## Response to Submissions and Additional Information

John Hunter Health Campus, Lookout Road, New Lambton Heights  
John Hunter Health and Innovation Precinct

Department of Planning, Industry and Environment  
On behalf of Health Infrastructure NSW

27 August 2021 | 2190777

**Figure 7 Northern road alignment as refined**

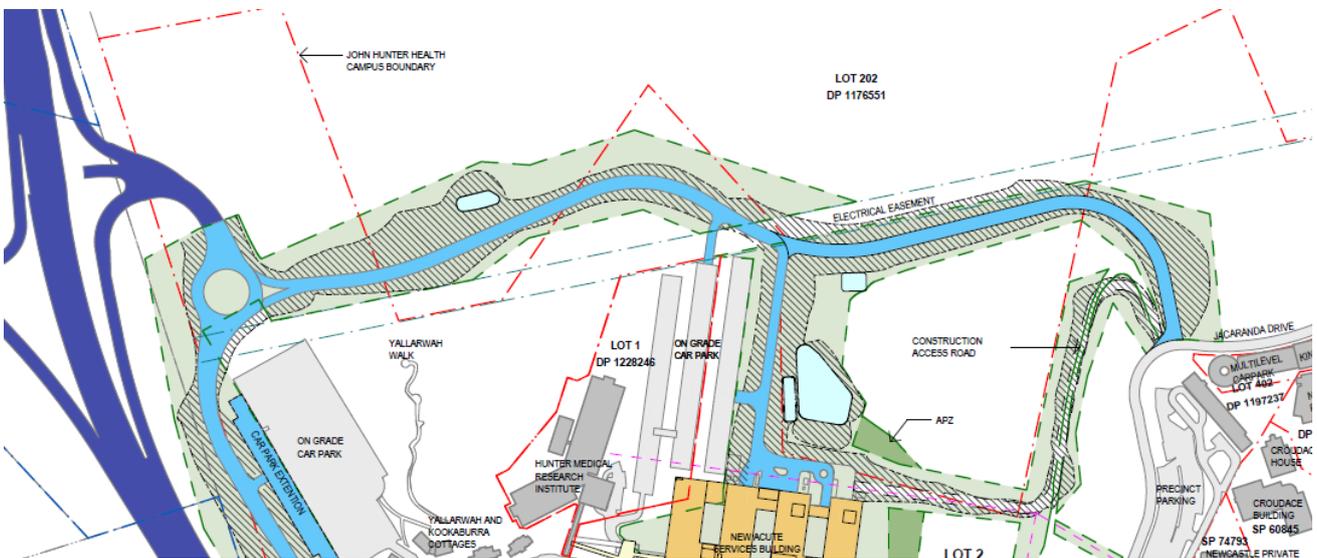
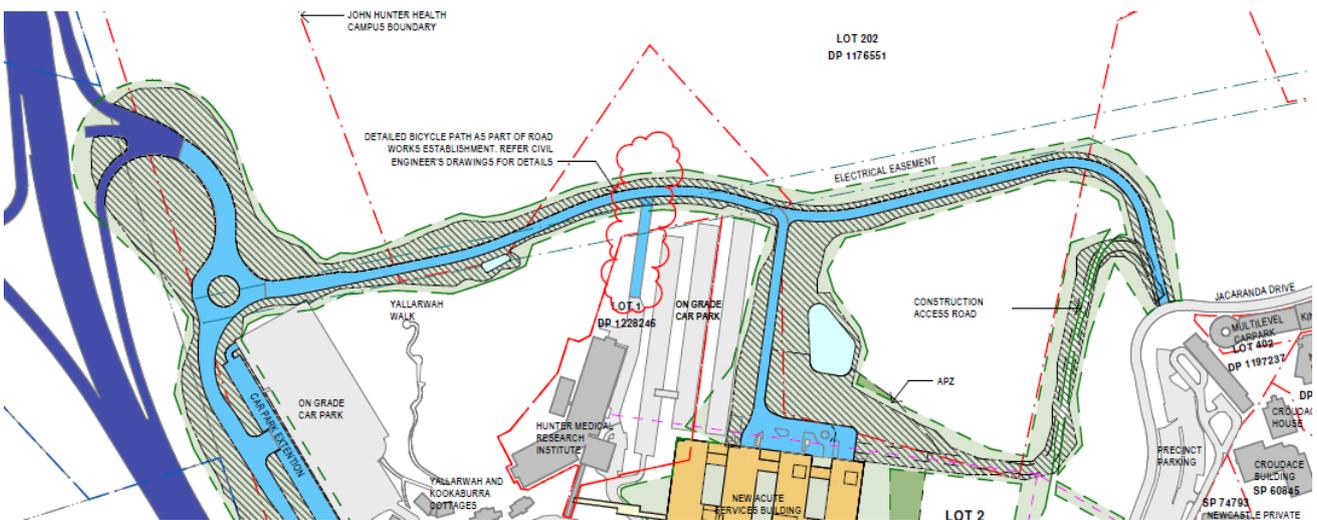
This application proposes a refined realignment of the northern road to the NICB, as shown in **Appendix B** and **Appendix G**. The realignment will reduce associated cut and fill volumes, reduce the road length due to a 'straightening' of the alignment, adjust the location of the biofiltration and detention system and minor realignment of the intersection with Jacaranda Drive to improve driver sight lines. The refined layout also better aligns with the electricity easement which will reduce impacts on vegetation as the easement is already clear of vegetation.

The refined design requires less bulk excavation and as a result, decreased impact on vegetation. As per the revised BDAR Assessment at **Appendix J**, the realignment results in vegetation clearing of 4.7ha as compared to 7.2ha in the original proposal,

The proposed realignment will not have any impact on the previous traffic assessment undertaken in regard to the link to the NICB or vehicle circulation. GTA have reviewed the design refinements and confirm that compliance with the relevant Australian Standards can be met (See **Appendix P**).

**Figure 8** Proposed bridge on the western link road, as clouded in red.

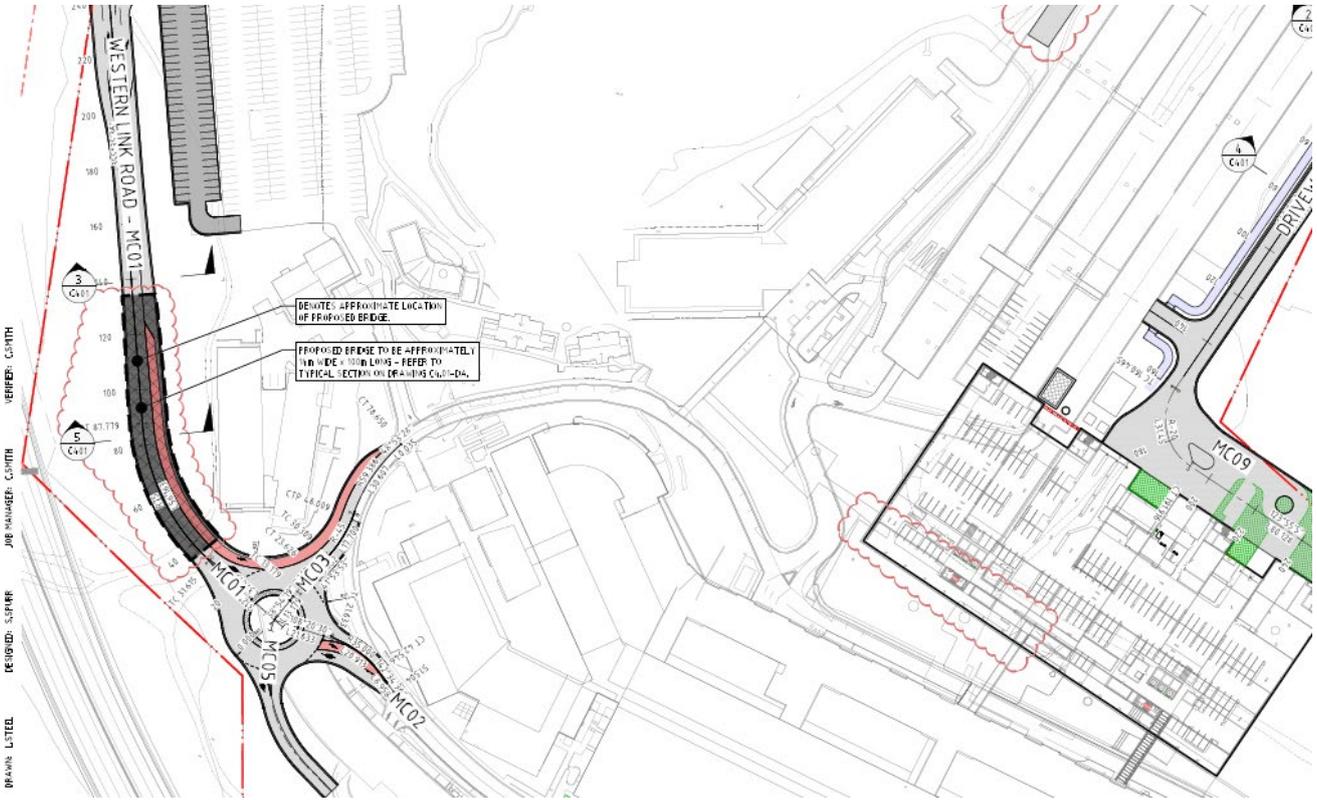
It is proposed that a bridge is included along the western link road to reduce filling and retaining wall extents. The proposed bridge is shown in **Figure 8**. This is a result of ongoing design development and engineering of the project to provide a better relationship of the road to adjacent buildings by reducing the steep batters with a bridge that will be less visually intrusive. The inclusion of the bridge does not result in any alteration to the previously considered environmental impacts, including biodiversity or traffic impacts.

**Figure 9** Refined gravity fed sewer line

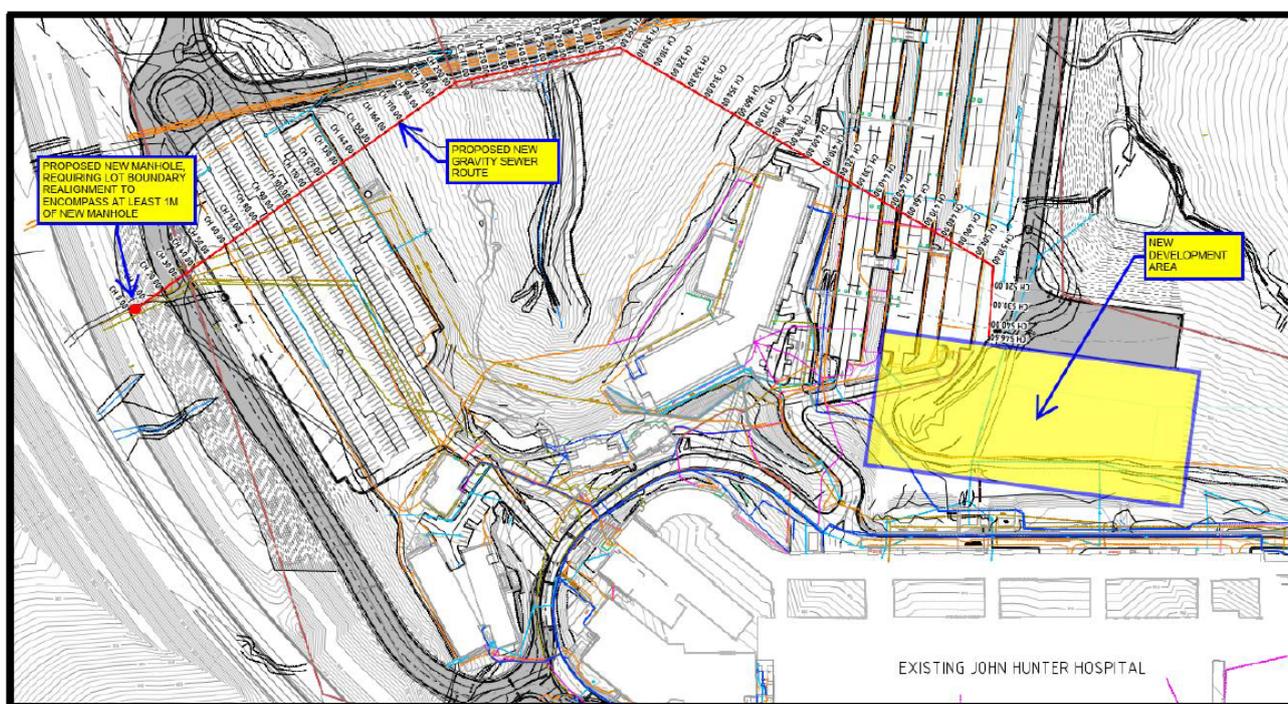
The refinement of the gravity-fed sewerage system servicing the ASB is proposed as a result of correspondence with the Hunter Water Corporation, as discussed further in the amended Hydraulic and Fire Services Report (**Appendix M**). A new 300mm private sanitary drainage pipe is proposed for the ASB. This will provide an option to eliminate the requirement for the sewer pump station and provide capacity flexibility for the future Stage 2 development. These works do not generate any subsequent impacts (such as vegetation impacts).

The location of the gravity fed sewer line is shown at **Figure 9**.

**Figure 11** Basement design as proposed (level 2)

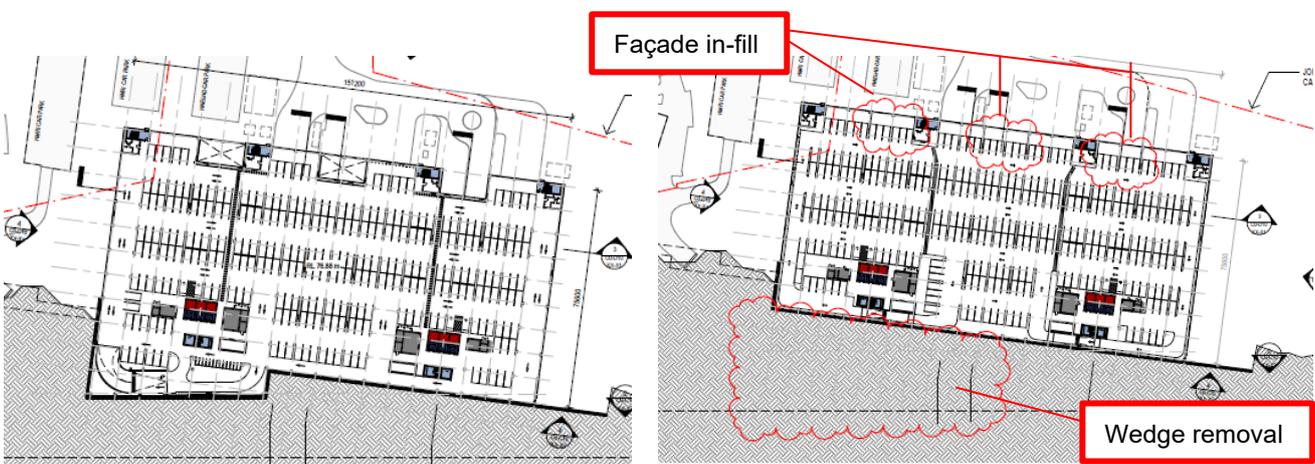
The building footprint has been refined to make the basement levels rectangular in shape. This refinement decreases previously available cut material from the ASB footprint and is proposed across all four levels of basement. The previously exhibited basement design (level 2 for reference) is shown at **Figure 10**, and the proposed basement design is shown at **Figure 11**, with the proposed infill elements to the façade and removal of the 'wedge' shown clouded in red. Minor refinements are also proposed to lower the level of the ASB basement level B4 by approximately one metre to improve carpark efficiency and clearances to building services.

The refined car park layout will result in minor changes to vehicle circulation. A statement from GTA consultants confirms the proposal can comply with the Australian Standard for Off Street Car Parking (AS/NZS2890.1:2004 and AS/NZS2890.6:2009) (see **Appendix P**).

Spatially, the civil design is unchanged, however bulk cut and fill volumes have been modified to reflect the refinement. Overall, the design refinement reduce the extent of excavation required for the project which is an improved environmental outcome for the project.
